Eastern Creek Karts Modification 1

Event Car Park Area – Earthworks, drainage, carpark and landscaping works

State Significant Development Modification Assessment (DA-S29/3/97-Mod-1)

Published by the NSW Department of Planning, Industry and Environment

Figure 5 | Proposed Civil Works

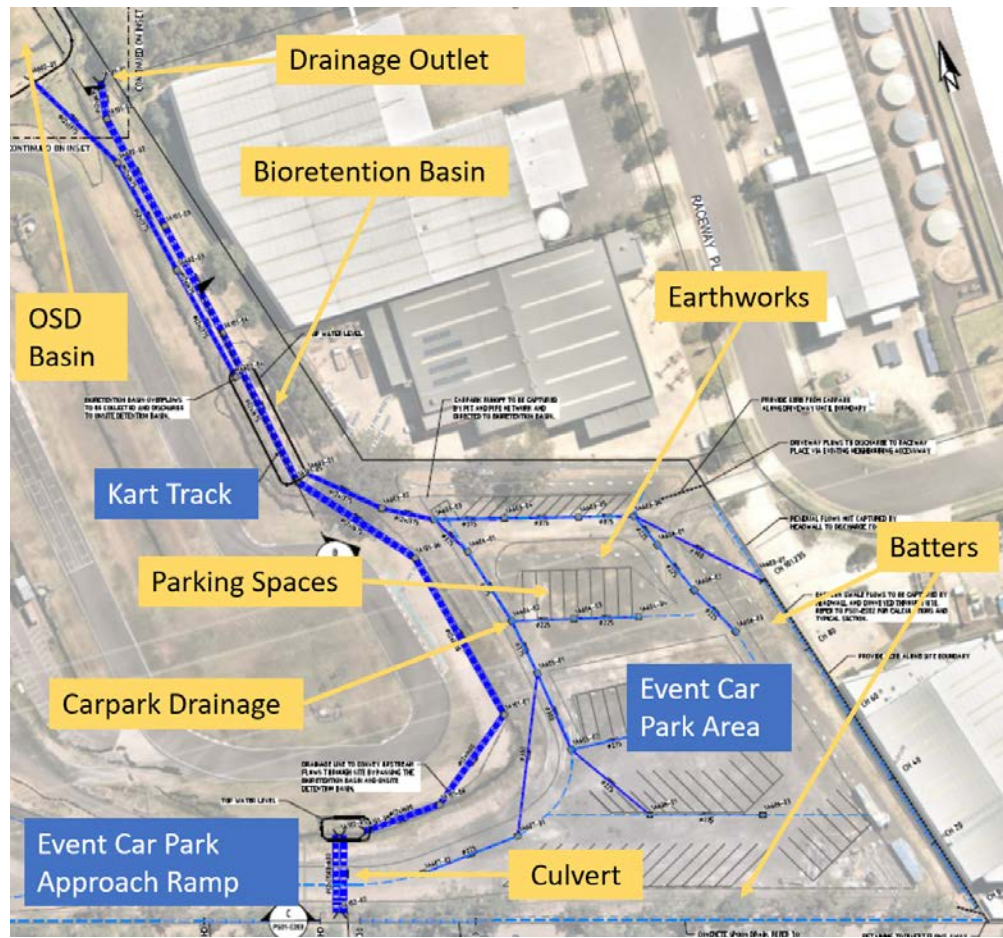
To manage upstream runoff within the event carpark area, the modification works would involve the following drainage works which provide additional safety in rare cases of partial pipe blockage and which are consistent with drainage design standards (see **Figure 5**):

- the installation of two new car park approach ramp culverts and drainage swales for up to the PMF event
- a trunk drainage system to convey storm flows up to the 20-year Average Recurrence Interval (ARI) within the site
- a major overland flow path system above the drainage pipe system to convey storms up to the 100-year ARI.

The Department is satisfied the proposed drainage infrastructure would have adequate capacity to ensure stormwater runoff would not be impeded by the fill works and can be safely conveyed from the site. The Department notes the drainage infrastructure would also provide flooding protection for properties in Raceway Place and would be consistent with Council's flood management guidelines. The Department has recommended conditions in the modification instrument detailing the design requirements of the proposed drainage infrastructure. This would ensure the proposed drainage infrastructure has been designed to reduce the flood risk to adjacent properties up to the PMF event.

The Department has also recommended design requirements for on-site detention and a water quality treatment system in the recommended instrument. The Department is satisfied these requirements would resolve matters regarding erosion, sediment and water quality raised by submitters, Council and WaterNSW. The Department also notes the existing development consent has conditions relating to erosion and sediment control measures for the operation of the site including a first flush system to treat stormwater at pollutant source points.
